PROJECT	Brickline Greenway North Connector – Phase 2	ADDENDUM NUMBER	01
PROJECT NO.	14654 (GRG 308s)	DATE	9/1/2026
PROJECT LOCATION	St Louis, Missouri		
CLIENT	Great Rivers Greenway		
PREPARED BY	Hannah Higgins, SmithGroup

ADDENDUM #01

Proposed changes include the following updates and the related pay item, bid tab, and JSP adjustments required:

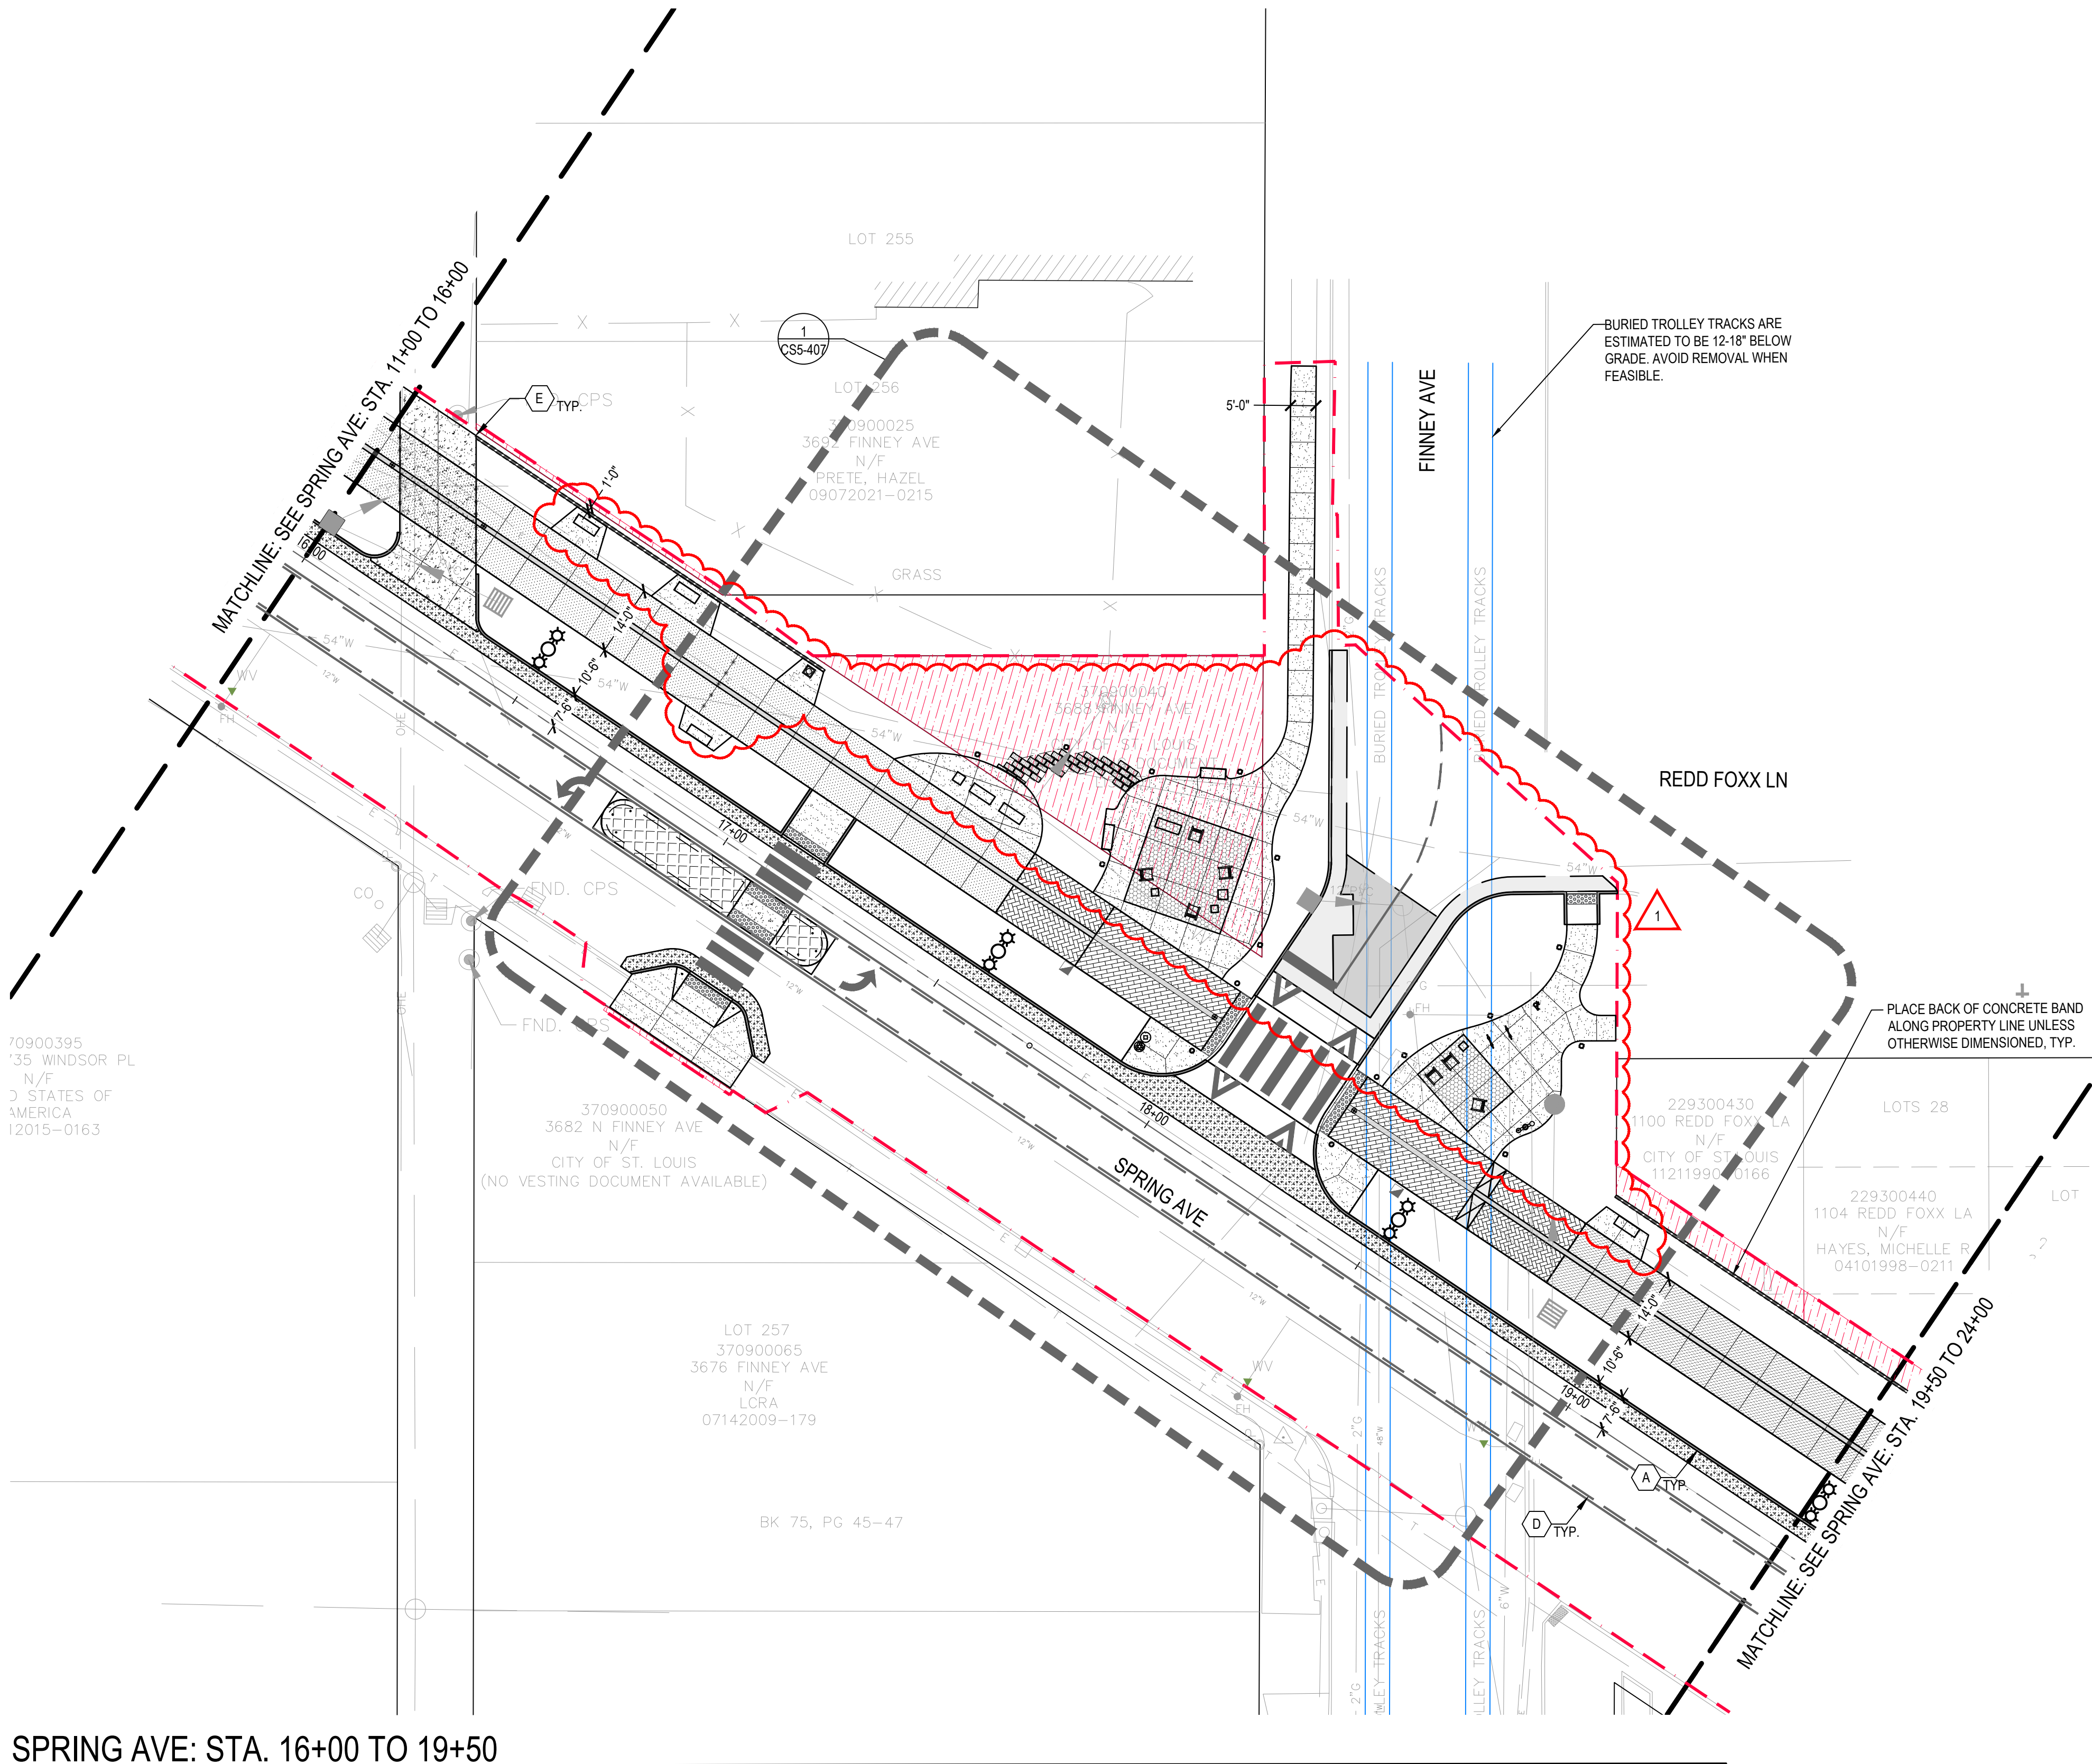
B. CS4-105 DEMOLITION PLAN – SPRINT – AREA 5: Adjusted limits of full depth pavement removal area and mill and overlay area.

CS5-105

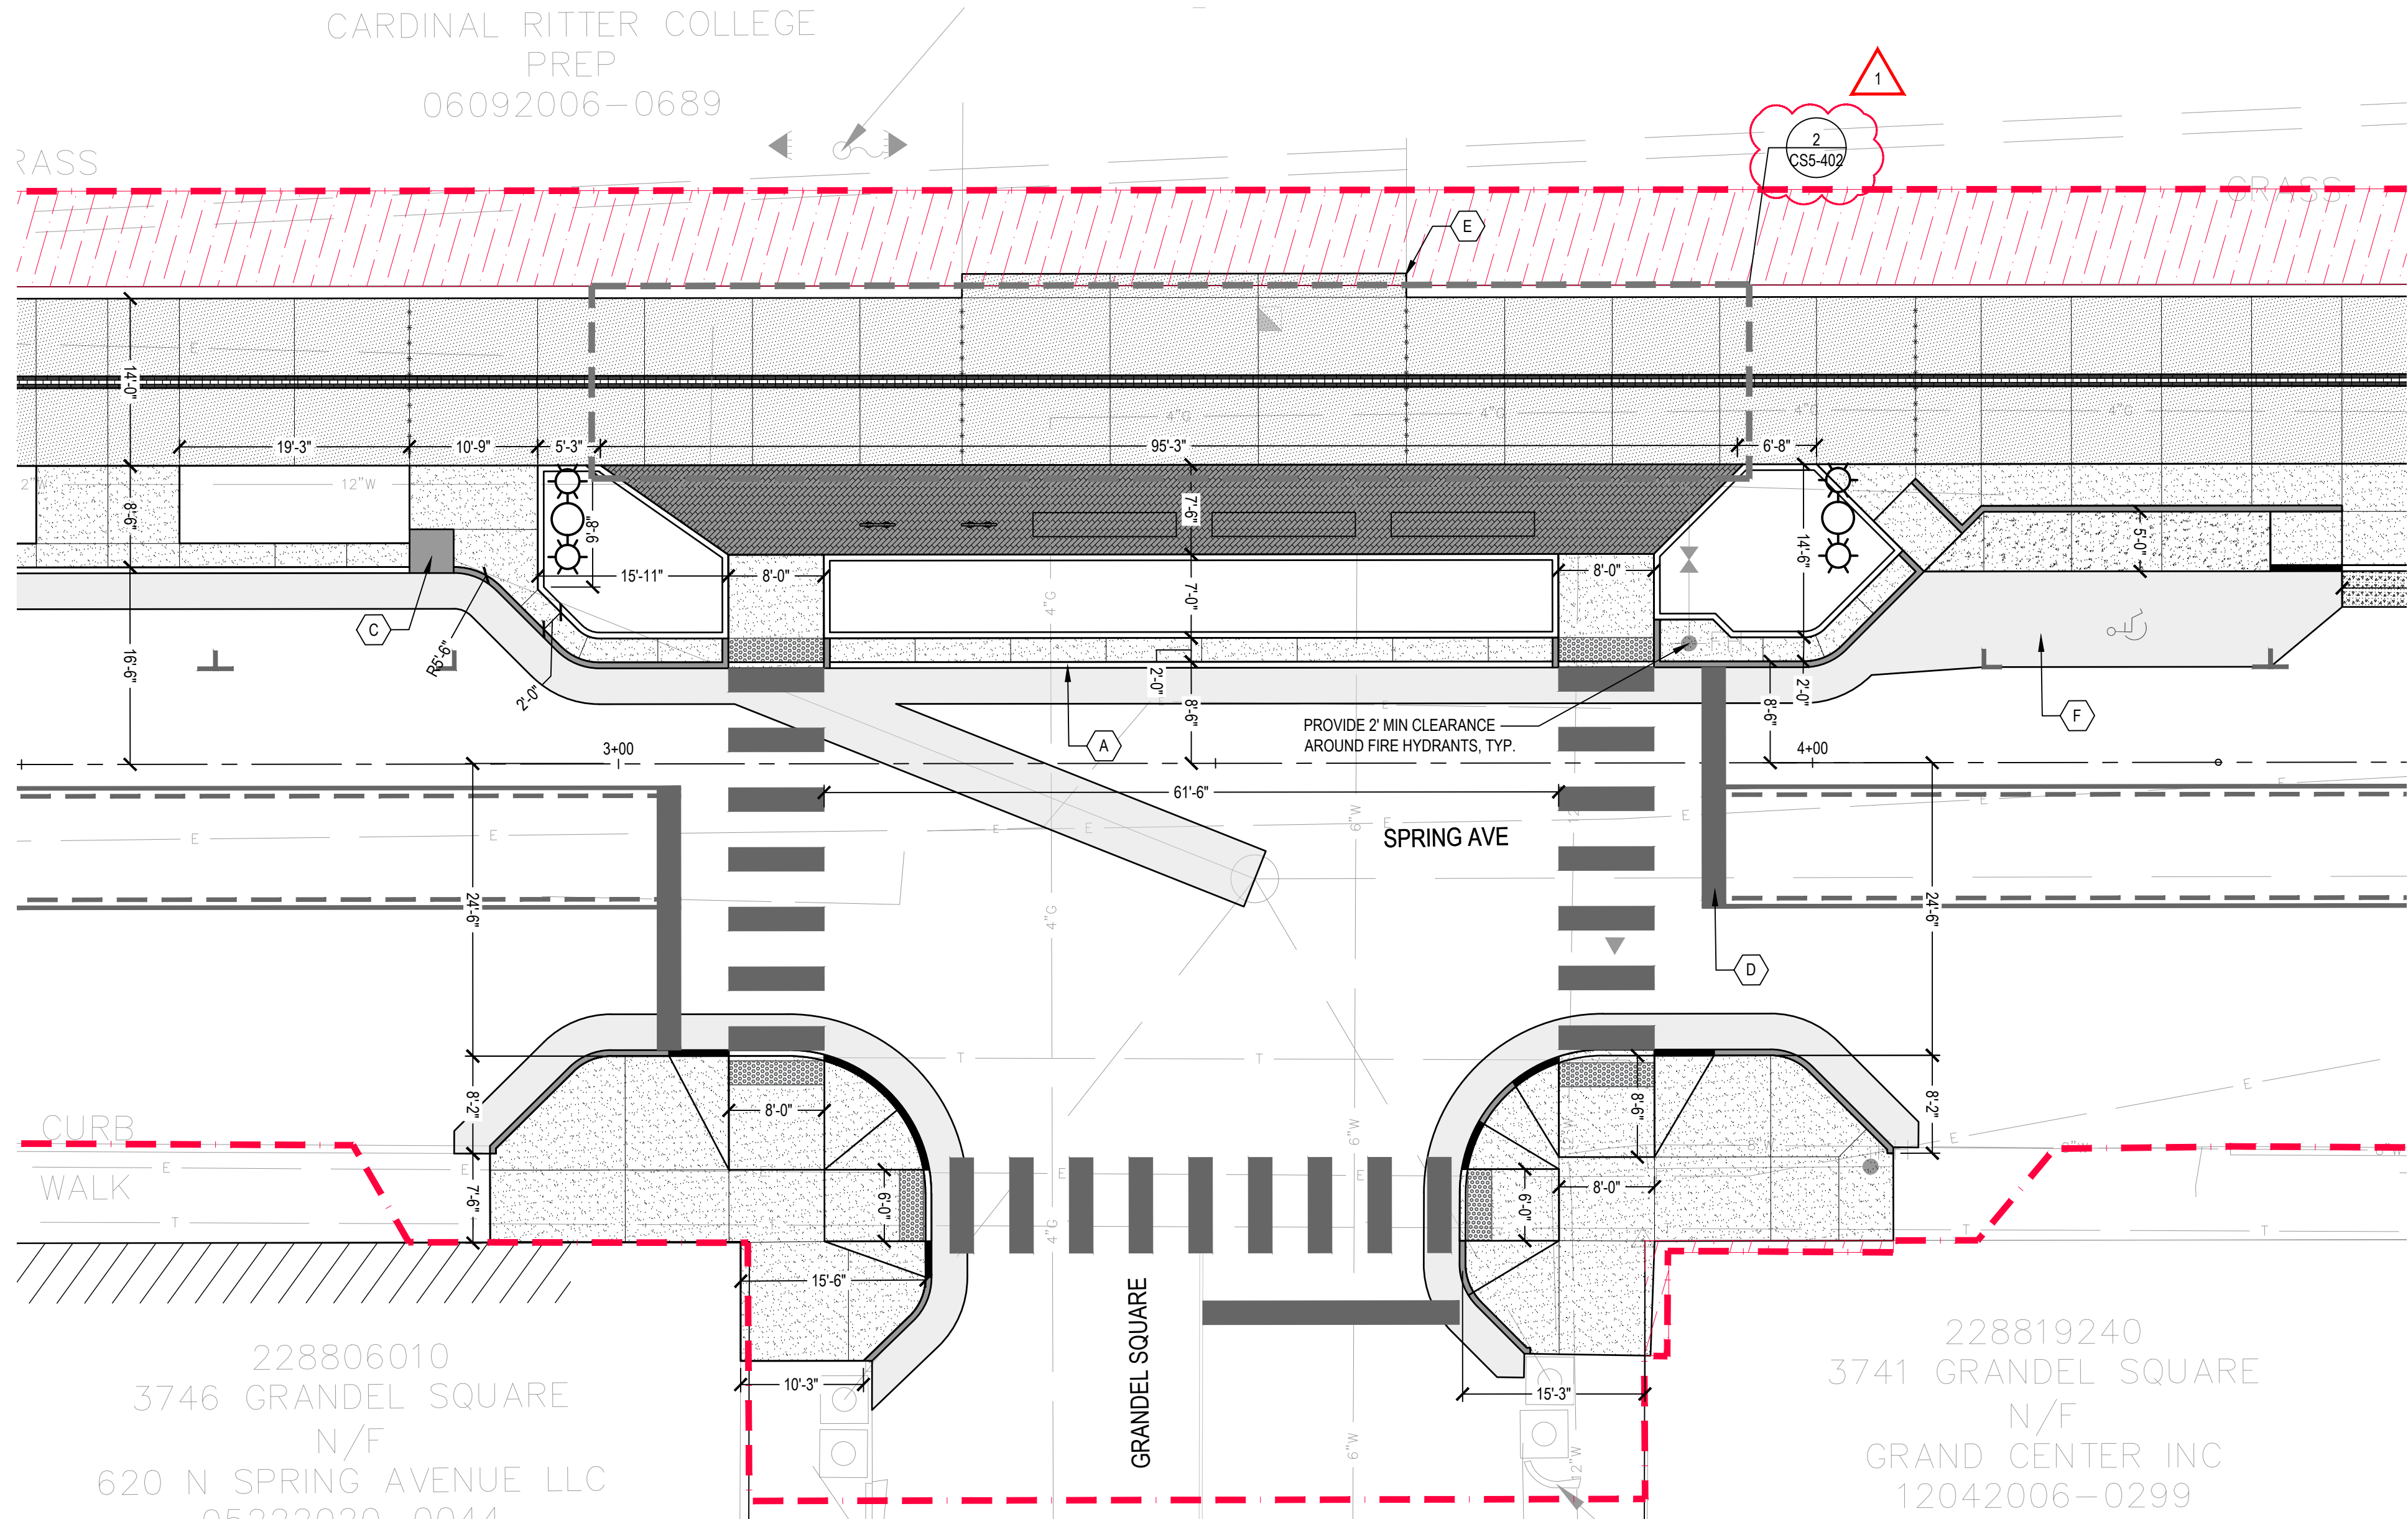
- C. CS5-105 LAYOUT AND MATERIALS PLAN – SPRING – AREA 5: Plaza areas at Spring/Finney intersection updated.
- D. CS5-107 LAYOUT AND MATERIALS PLAN – SPRING – AREA 7: Sidewalk updated for relocated trail signage.

CS5-402

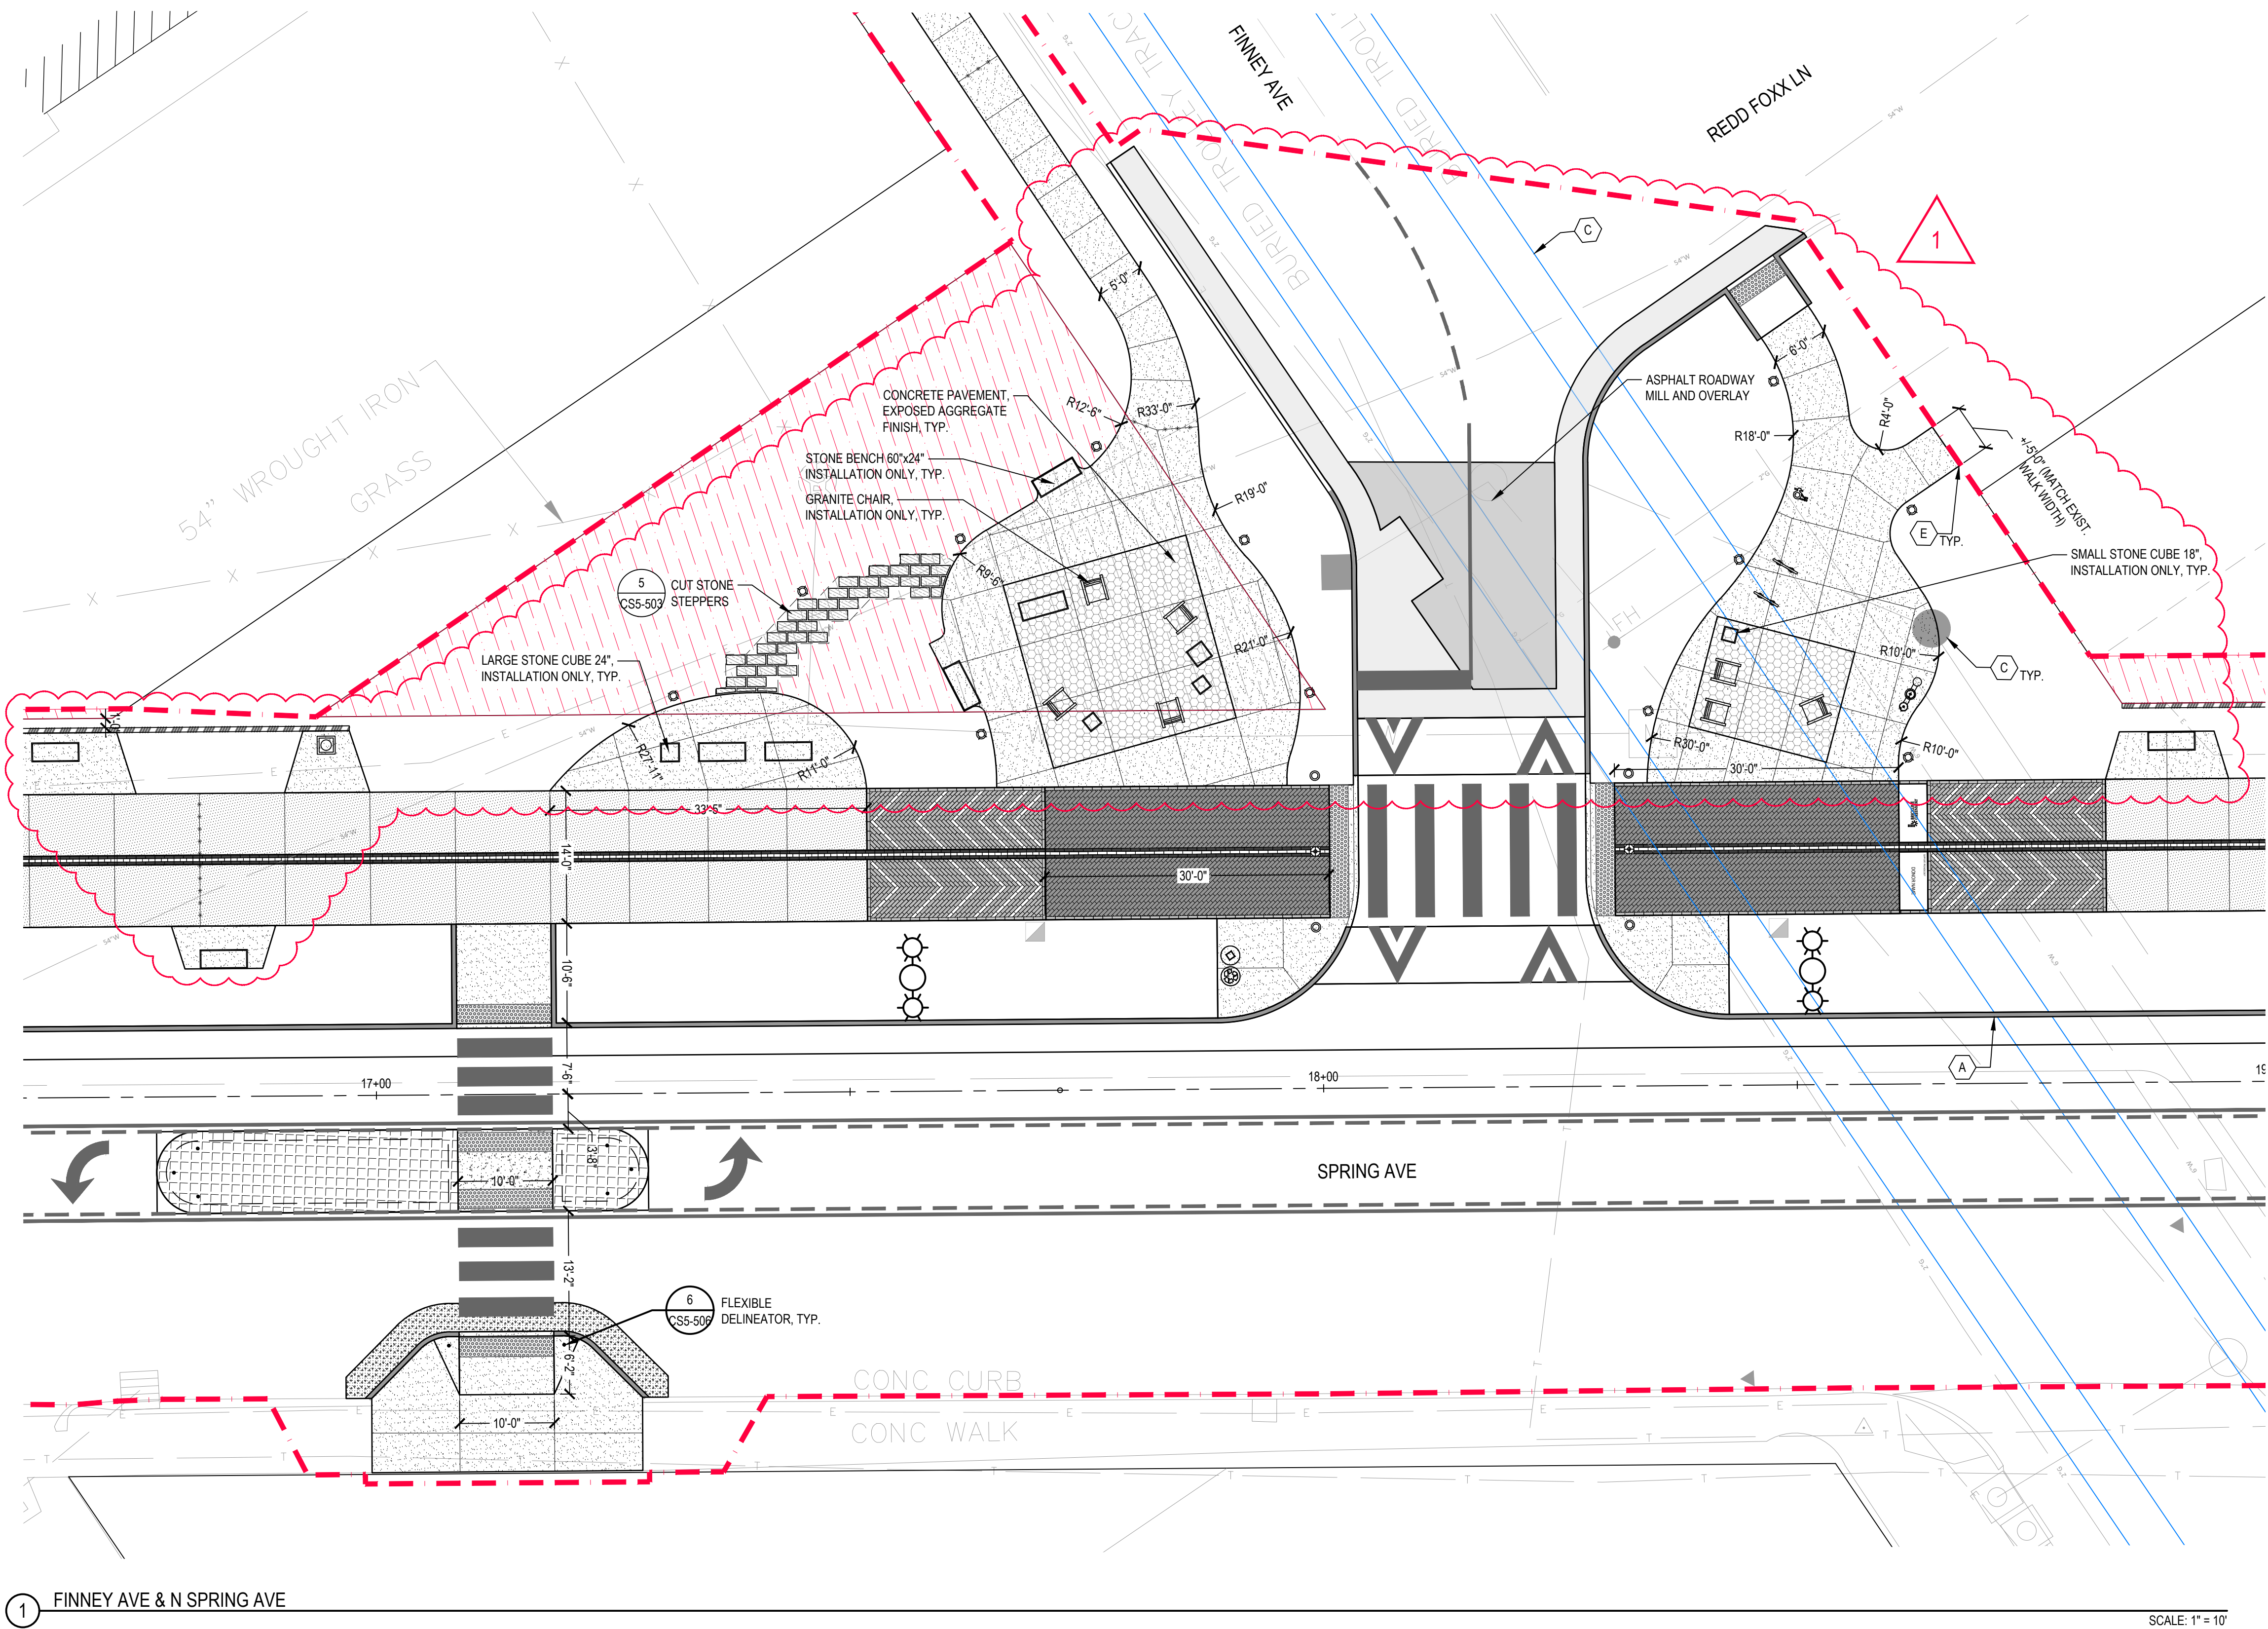
- E. CS5-402 LAYOUT AND MATERIALS PLAN ENLARGEMENTS: Alternate #2 added.
- F. CS5-407 LAYOUT AND MATERIALS PLAN ENLARGEMENTS: Plaza areas at Spring/Finney intersection updated.
